North American Tungsten Corporation Limited

RESPONSE TO YESAB'S ADEQUACY REVIEW REPORT
OF SUPPLEMENTARY INFORMATION RESPONSE
FOR THE PROPOSED MACTUNG MINE, MACMILLAN PASS, YUKON
(YESAB PROJECT NUMBER: 2008-0304)

ADDENDUM 2 OF THE MACTUNG PROJECT PROPOSAL

EBA FILE: W23101211.002

G:\Vancouver\GIS\ENVIRONMENTAL\W23101211_MactungMap02.mxd modified 10/1/2009 by mzondevan

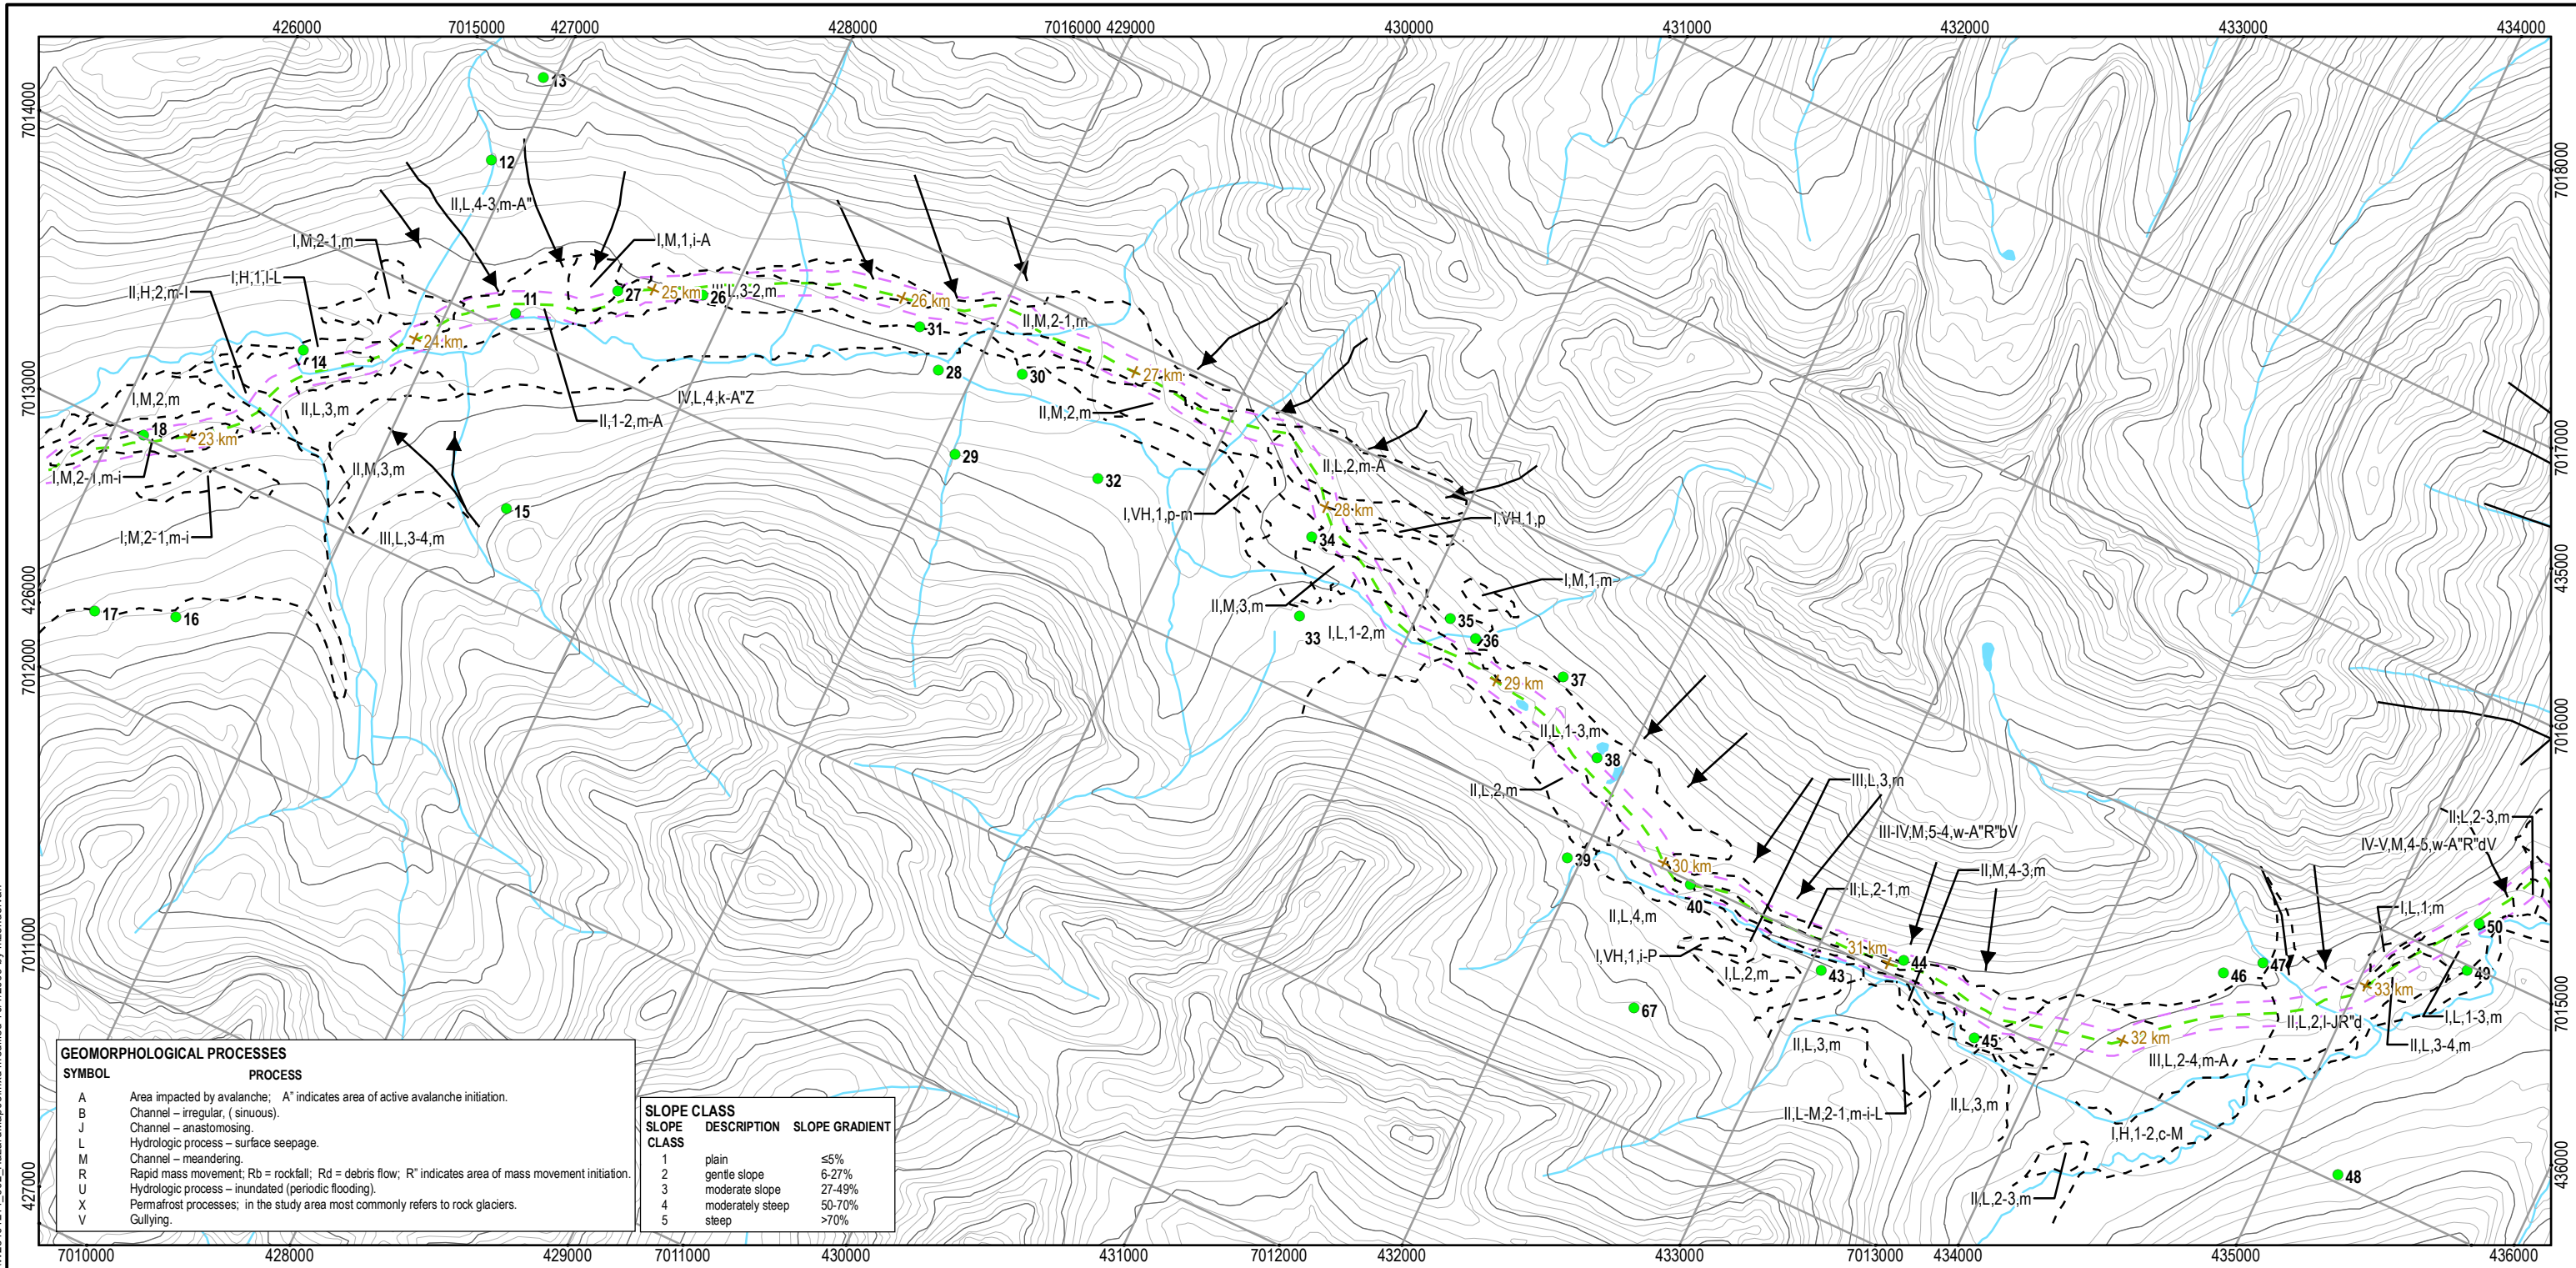
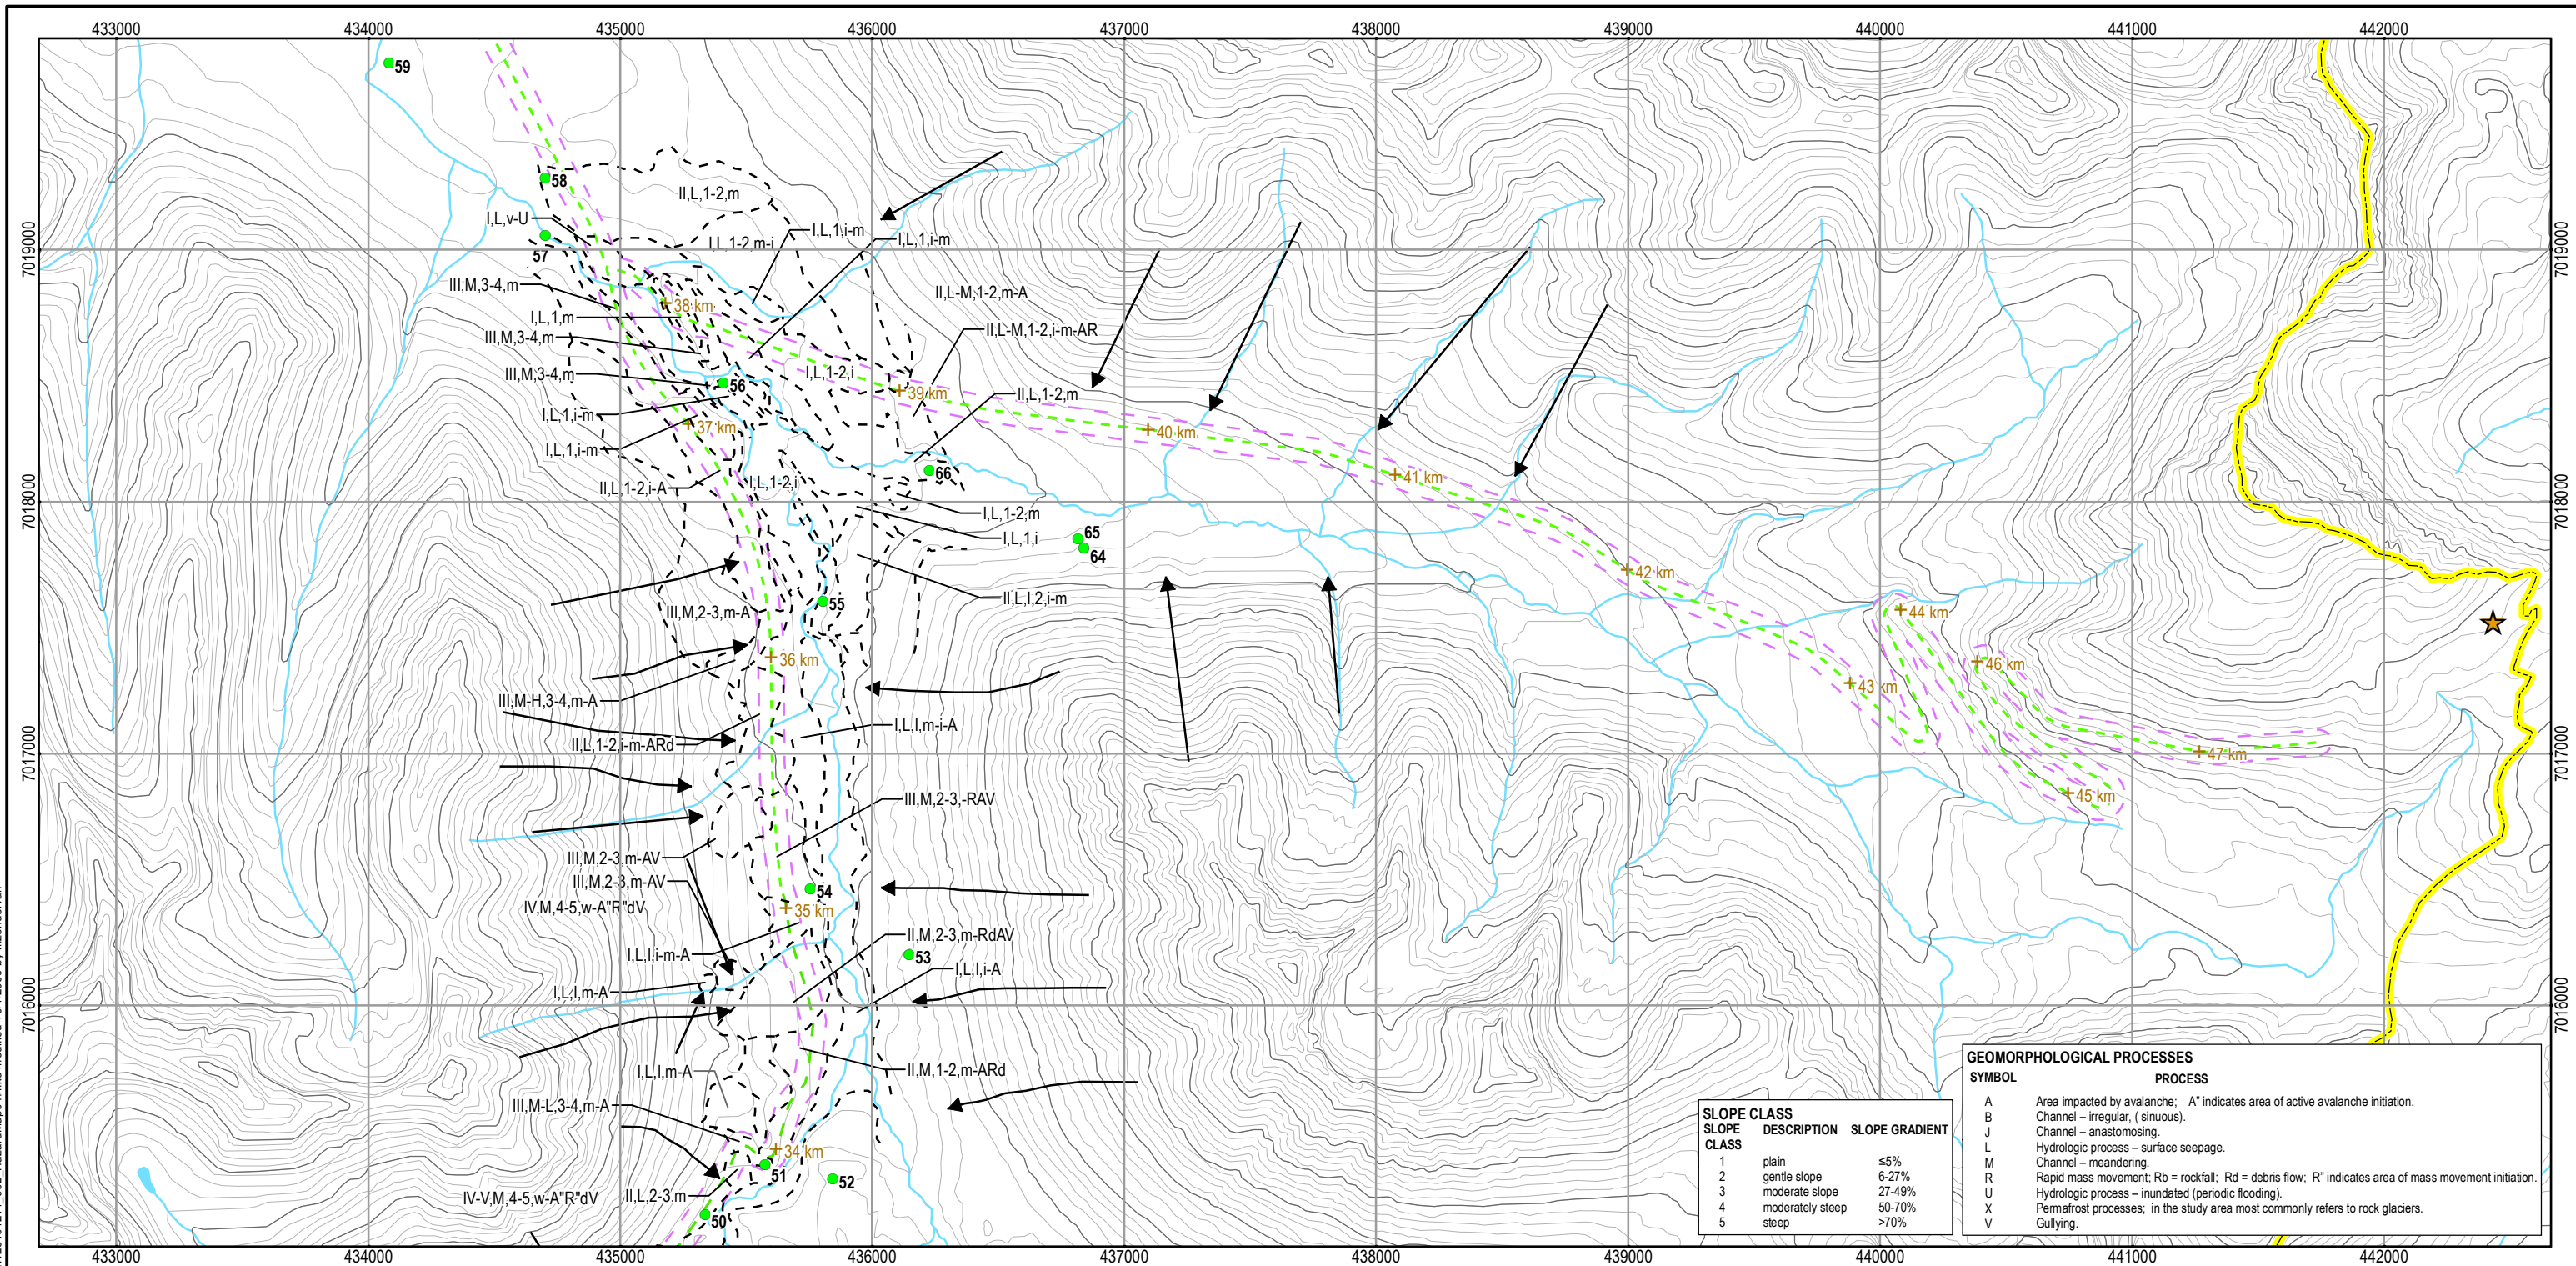
- a) A route map at an appropriate scale to show the location of the proposed access road relative to surrounding terrain features and topography, particularly those terrain units that could constrain routing (geo-hazards). An example of appropriate terrain mapping for linear developments can be found in the proposal for project #2006-0286 (Yukon Energy Corporation Carmacks-Stewart/Minto Spur Transmission Project).

Please refer to Figures 1.1-1.5 contained within Appendix B for mapping of the proposed mine road and associated terrain features. The Figures have been identified as "Preliminary" as they have been developed for assessment purposes only and are not suitable for site construction.

It should be noted that Figures 1.1-1.4 displays terrain hazard mapping based on an analysis of the area along the road route from the North Canol Road to approximately ten kilometres from the mine. Figure 1.5 presents the terrain mapping for the remaining ten kilometres in the immediate mine area with more detail, as a result of the extensive ground work conducted by NATC in the mine site area on the companies mining claims.

Figure 1.6

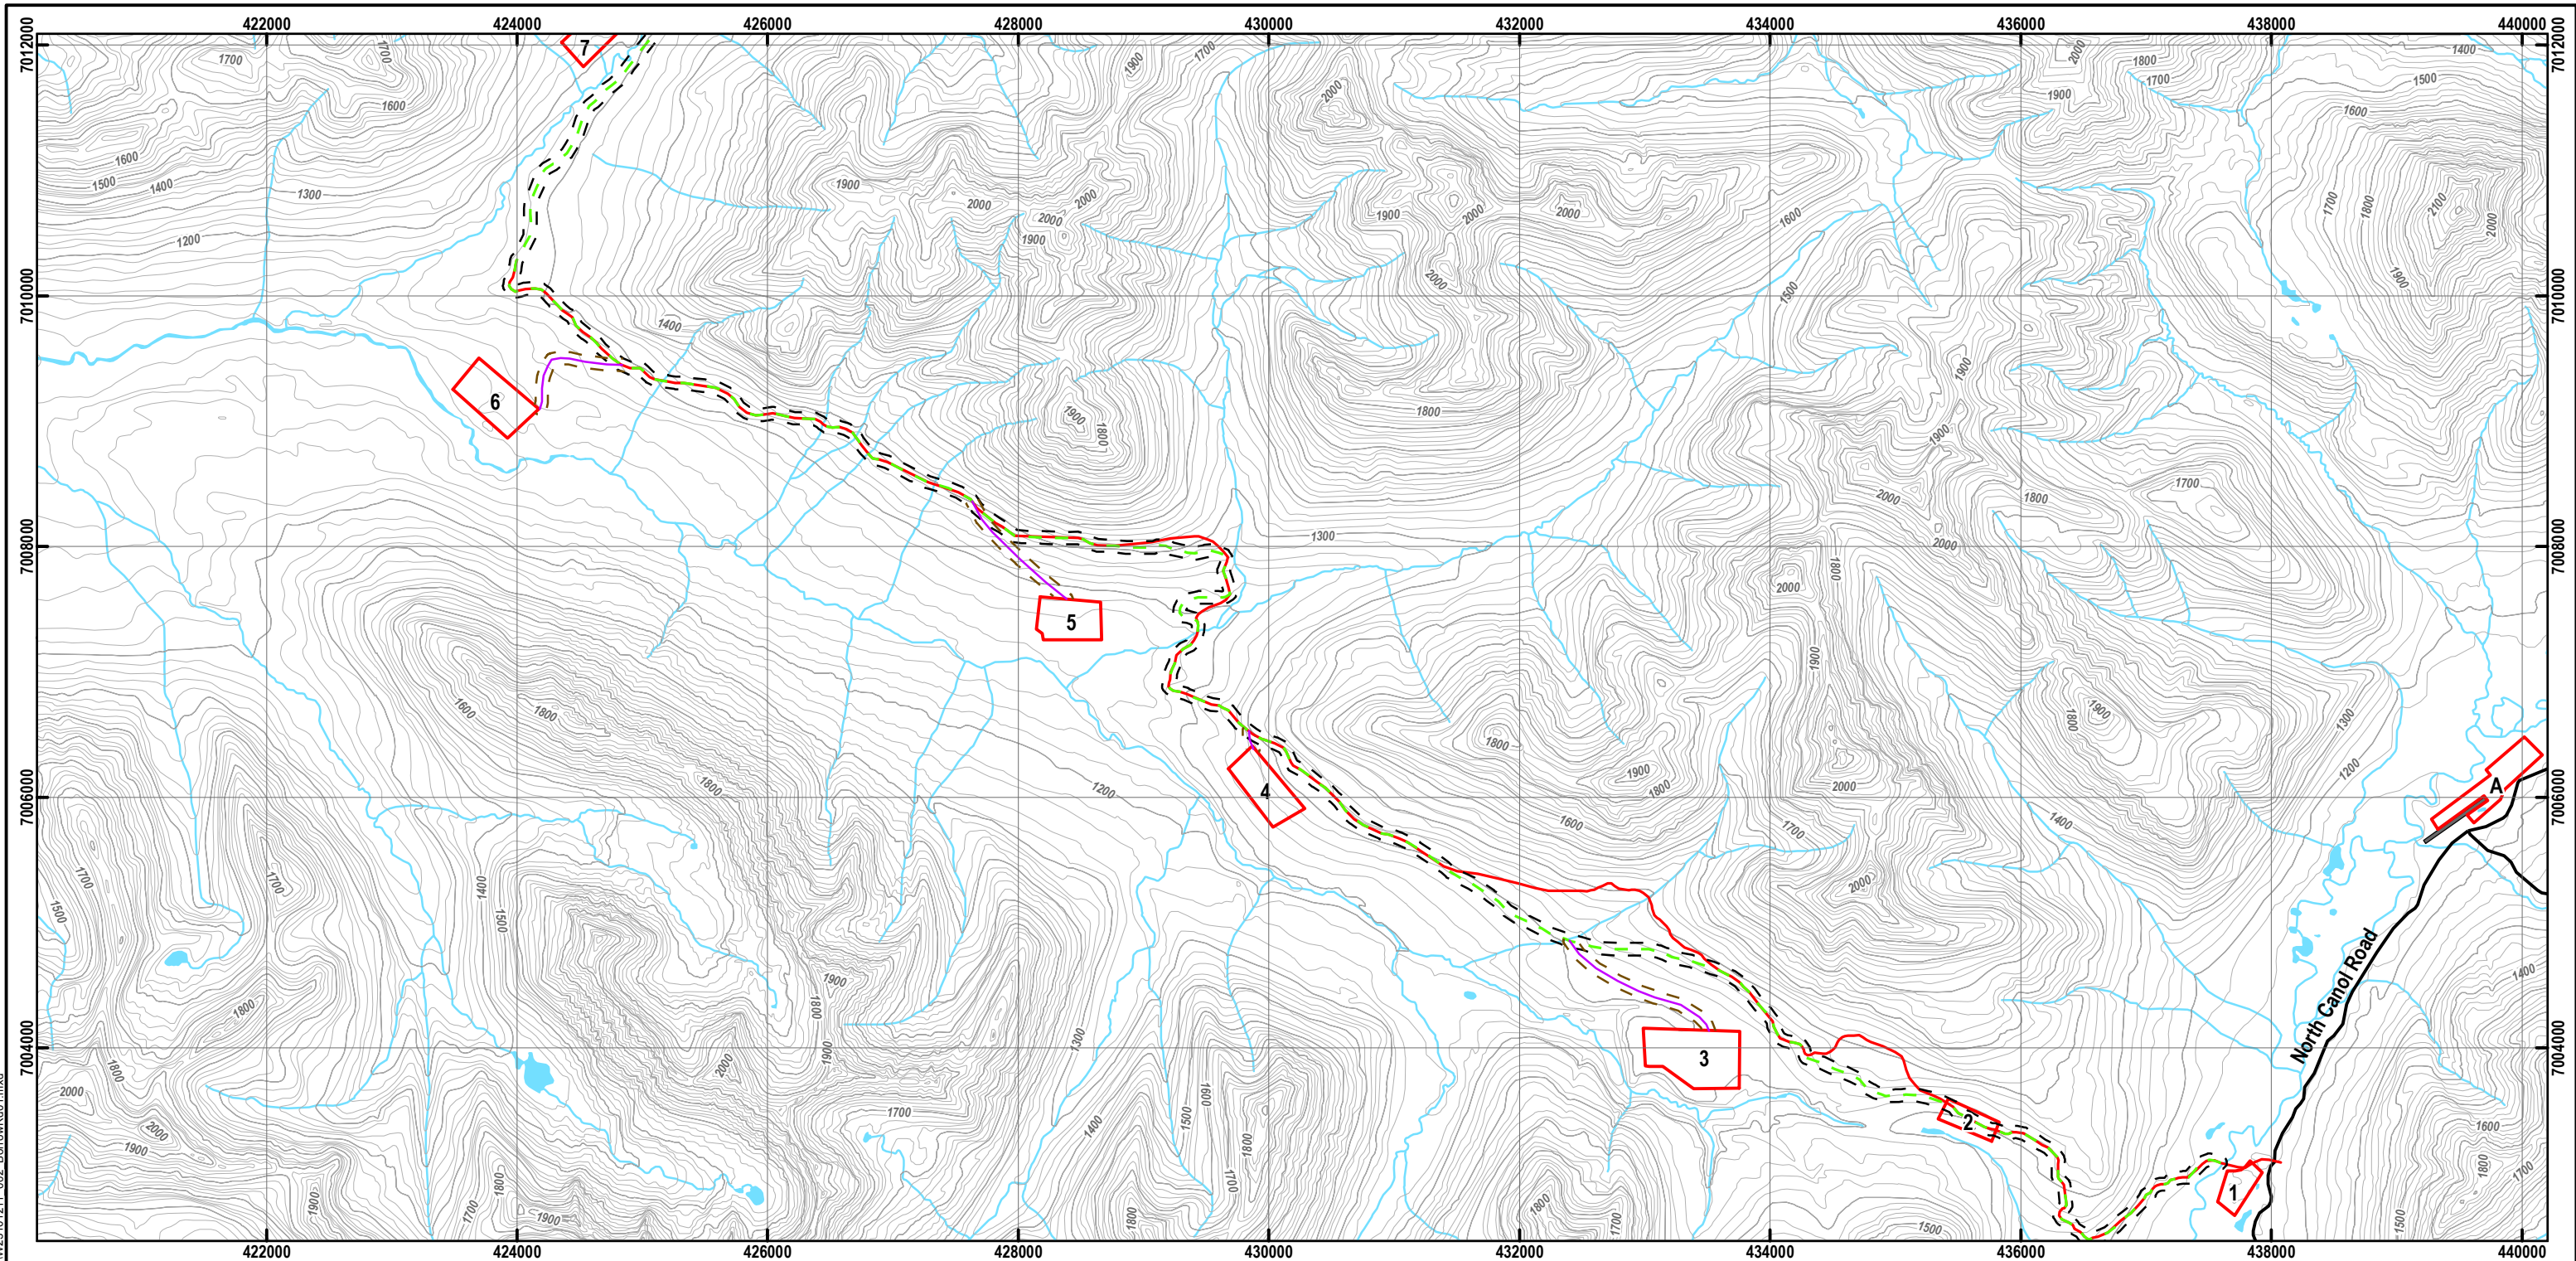
- b) Provide the proposed access on the route map where additional access will need to be constructed for the borrow sources identified in Figures 3.1.1-1 and 3.4.1-2 (Response to Adequacy Review Report).

Please refer to Figures 1.6-1.7, contained within Appendix B, for a presentation of borrow sites and their proposed access routes. It should be noted that borrow sites 1, 2, 9, 10, 11, 12, and 13 overlap with the proposed road right-of-way and therefore will not require the development of access roads. Further, borrow sites 7, 14, and 15 may have more complex access requirements due to their physical location. For this reason NATC will consider these borrow sources as provisional. These sites will only be developed if the necessary material cannot be sourced from the other borrow pits in the area of road construction. As stated in Addendum 1, NATC has identified more borrow resources than it anticipates will be required.
